JRPP REF NO.	2010SYE023
RECOMMENDATION:	DEFERRED COMMENCEMENT APPROVAL
LOCATION:	ON THE WESTERN SIDE OF PENSHURST STREET BETWEEN CLANWILLIAM STREET AND CHURCH
APPLICANT:	PROPERTY DEVELOPMENT CORPORATION
OWNER:	THE UNITING CHURCH IN AUSTRALIA PROPERTY TRUST NSW
PROPOSAL:	CONSTRUCTION OF FOUR STOREYS RESIDENTIAL FLAT BUILDING WITH TWO LEVELS OF BASEMENT CAR PARKING
DATE OF LODGEMENT:	19 APRIL 2010
VALID APPLICATION DATE:	24 MAY 2010
REPORTING OFFICER:	ANNIE LEUNG – DEVELOPMENT PLANNER

DESCRIPTION OF PROPOSAL

Development application 2010/202 seeks consent for the construction of a residential flat building containing 41 dwellings. It will provide:

Attachment 2 - Plans & elevation

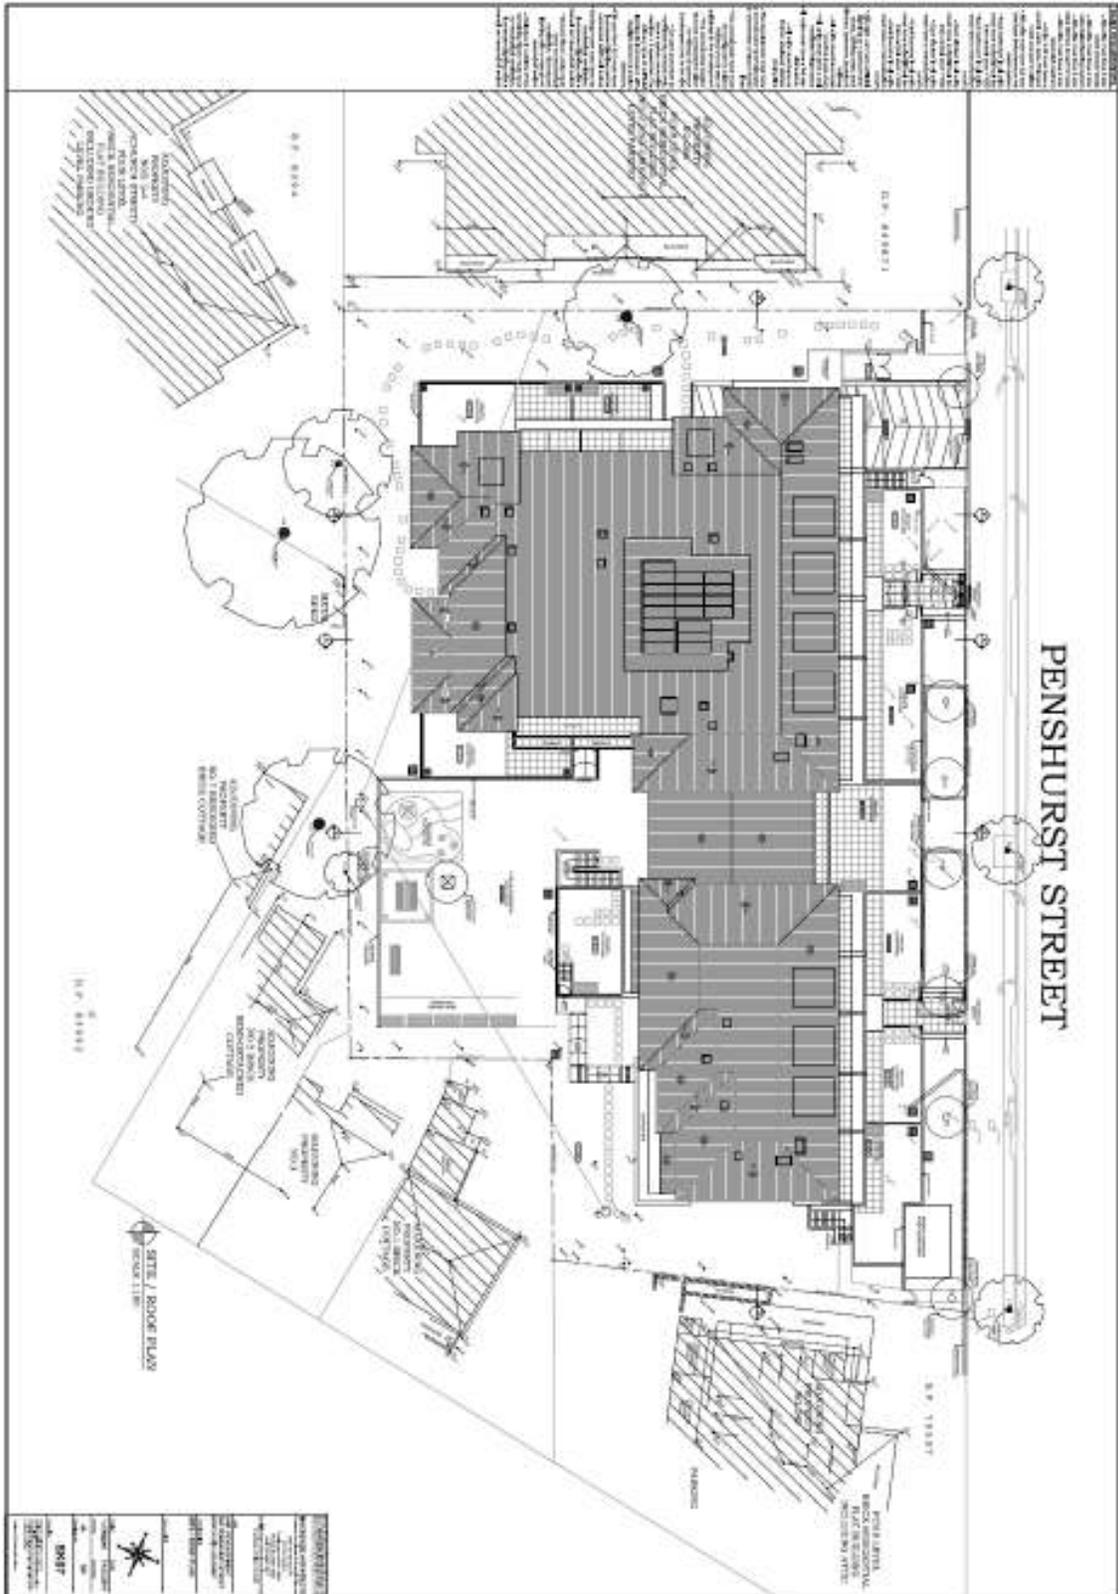
However, the proposed architectural approach results in excessive bulk due to the massive volumes of space enclosed by the side roof planes, and the roof forms have continuous eave and "ridge" lines as viewed from the street with limited setback from the lower levels. The proposed roof forms appear disproportional to the building, and reinforce its mass and length along its street frontage.

In addition, the proposed facades also need more design integration, and a consistent architectural language/expression. For example, the southern elevation of southern wing of the building appears to have too many material variations, but a lack of fenestration. Facebricks sparingly used on the southern wing of the development also appears inconsistent with the overall contemporary building appearance. In this regard, it is recommended that a revised schedule of material and finishes be submitted to address the redress the inconsistencies in materials composition of various elevations of the development. (**Def Comm. Condition D**)

The proposal be amended generally in accordance with submitted sketches numbered SK05/M (Second floor plan), SK06/M (Third floor plan), SK07/M (Roof Plan), SK08/M (Elevations), and SK09/M (Section DD), dated June 10, prepared by Mckenzie Architects, and the following amendments:

- i) Change in Dwelling mix, and reduce the total number of dwellings to 40 as follows:
 - 1. Deletion of Unit 41 (2 bedrooms);
 - 2. Conversion of Unit 32 to a 3 bedrooms unit,
 - 3. Conversion of Unit 38 from a 1 bedroom unit to a 2 levels, 2 bedrooms unit;
 - 4. Conversion of Unit 39 from 1 bedroom unit to a 2 bedrooms units; and
 - 5. Conversion of Unit 36 from a 2 bedroom unit to a single level, 1 bedroom Unit.

- v) All dormer windows shown on side and rear elevations of the third floor are limited to 1.2m wide and the head of the dormer windows must be at least 300mm below the ridge height of the associated roof plane.
